# Modifying a MALSR/ALSF Flash Head with a Trigger Amplifier Board Part Number 44A5903/1

## **Document No. ALN139**

Rev. B: March 20, 2008

# Modifying a MALSR/ALSF Flash Head with a Trigger Amplifier Board

Figure 2: Existing wiring inside flash head

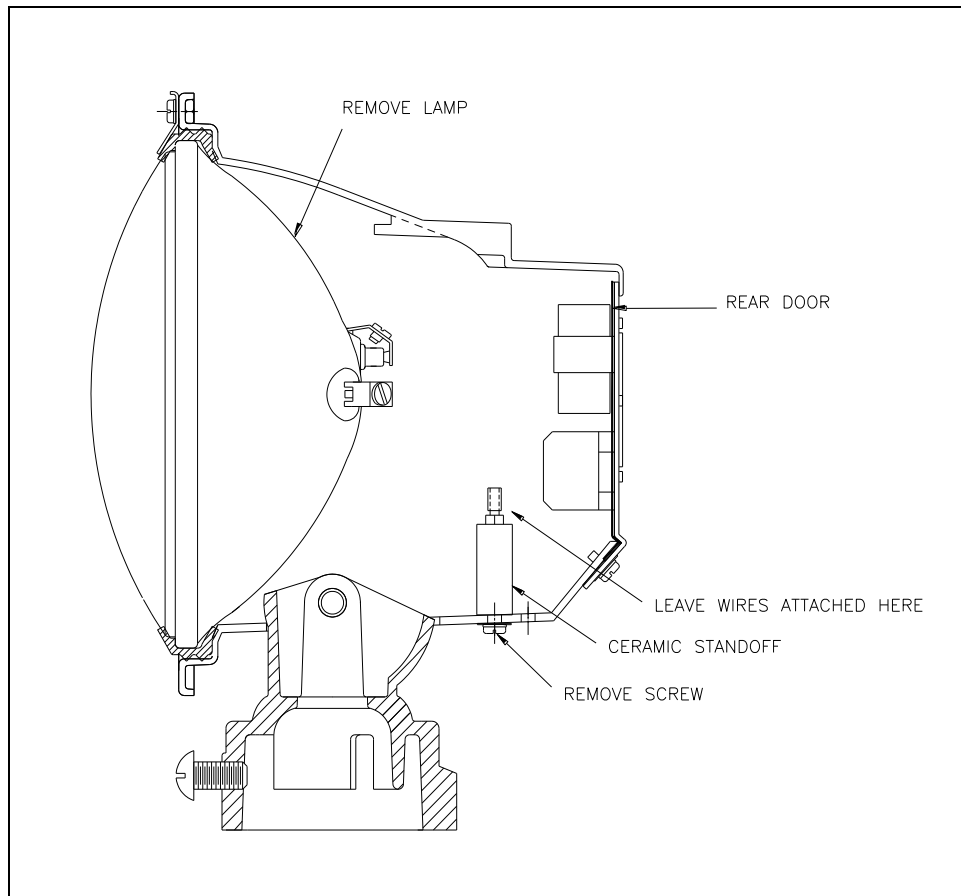
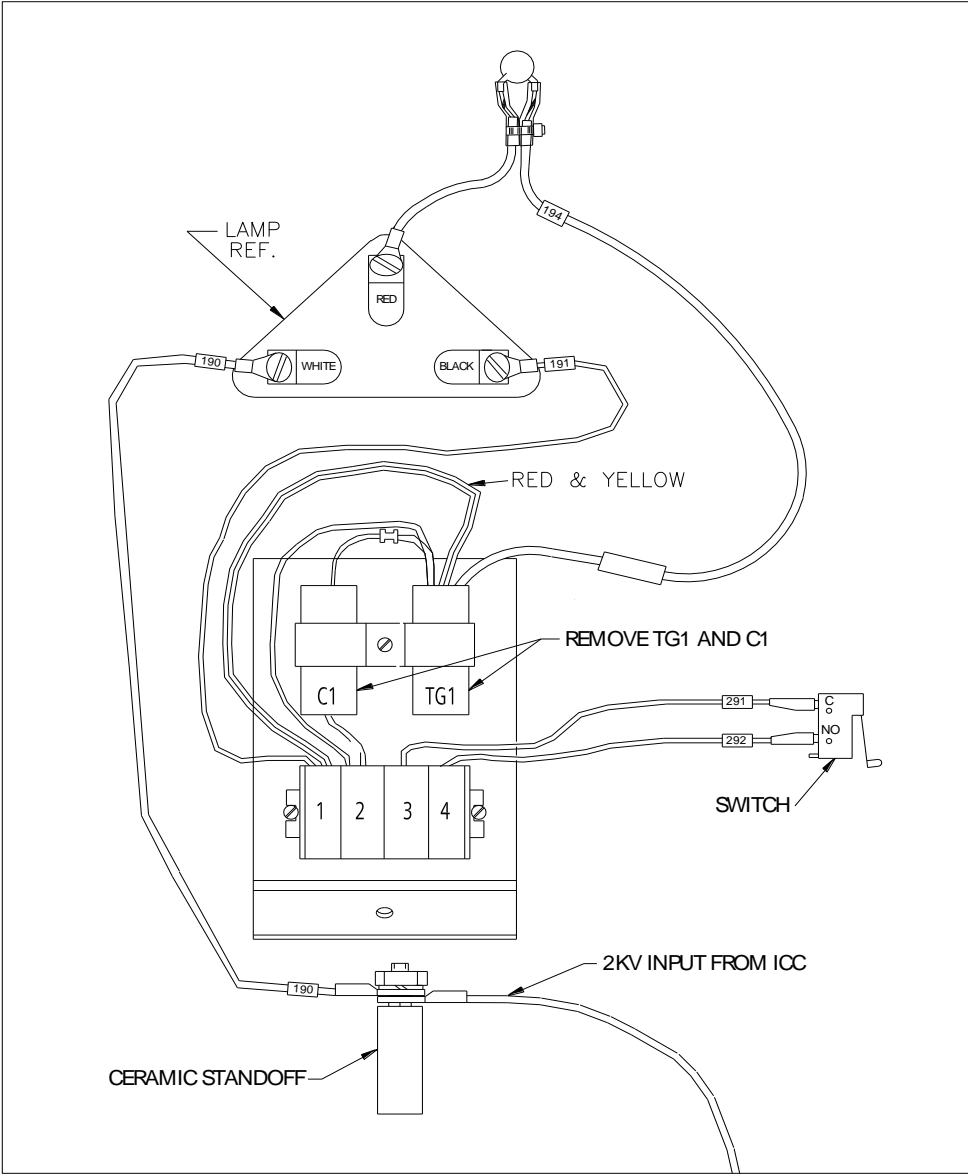
- 1) See Figures 1 and 2.
- 2) Open the back door of the Flash Head.
- 3) Remove the trigger transformer (TG1) and capacitor (C1) from the door. Replace the screw and lock washer to seal the hole in the door or seal with suitable RTV silicon.
- 4) Remove Trigger transformer's YELLOW and RED wires from terminal block (TB1) position 1. Be careful to leave wire #191 from the lamp in position 1.
- 5) Remove the capacitor's wire from terminal block (TB1) position 2.
- 6) Carefully remove the flash lamp from the front of the assembly. Gently let it hang from its wires.
- 7) Remove the lamp wire (with capacitor) from the lamp's RED terminal.
- 8) Remove the ceramic standoff from the inside of the unit by unscrewing the screw in the bottom of the assembly. Leave the wires attached to the ceramic standoff for now.

**Figure 4: Flash head "Modified"**

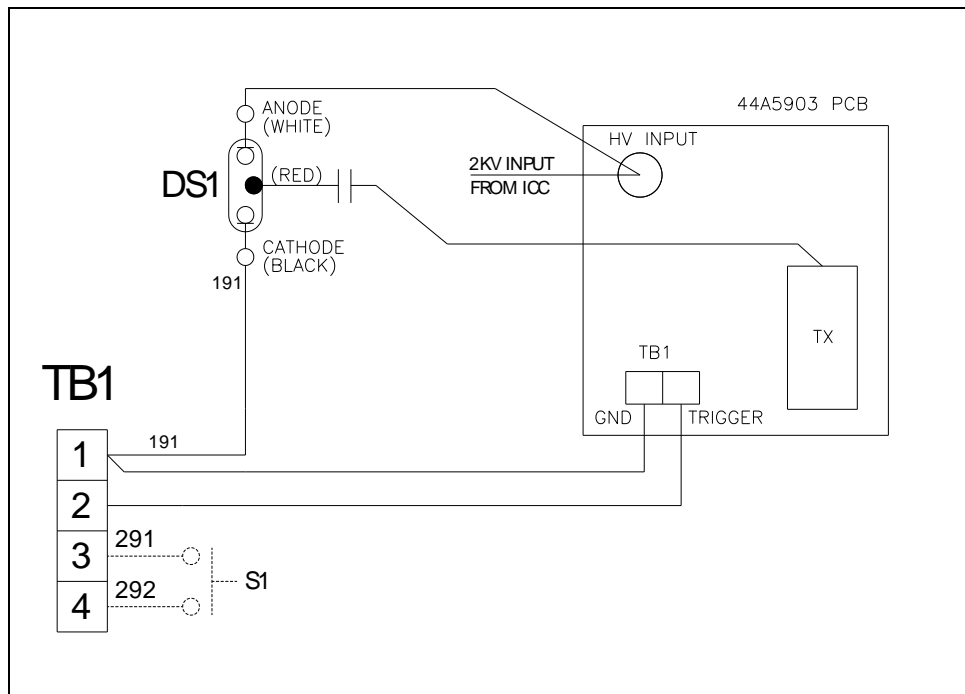
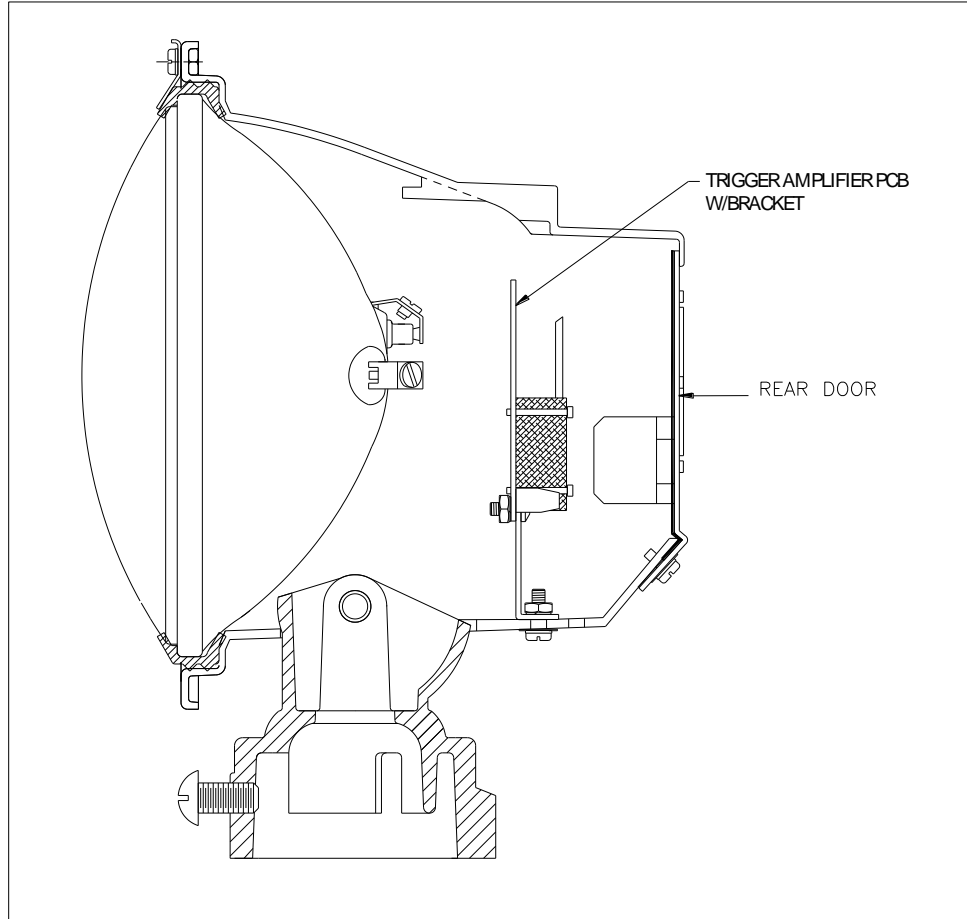
- 1) See Figure 3 for new wiring schematic.
- 2) Remove both wires from the ceramic standoff and connect to the “HV INPUT” terminal on the 44A5903/1 Trigger Amplifier Board.

- 3) From the lamp side of the housing, connect the wire from the Trigger Amplifier Board terminal (TB1) label “GND” to the door terminal block position 1. This wire should now be connected to wire #191 that goes to the lamp.

- 4) Connect the wire from Trigger Amplifier Board terminal (TB1) label “TRIGGER” to the door terminal block position 2.
- 5) Find the wire from the Trigger Amplifier Board Transformer that has a capacitor in series with it. Connect this wire to the RED terminal on the lamp.

- 6) Carefully insert the Trigger Amplifier Board into the housing and connect its mounting bracket to the bottom hole that the ceramic standoff used – see Figure 4.

- 7) Verify that your lamp assembly is wired per Figure 3.
- 8) Carefully reassemble the lamp and rear door.
- 9) The modification is complete.
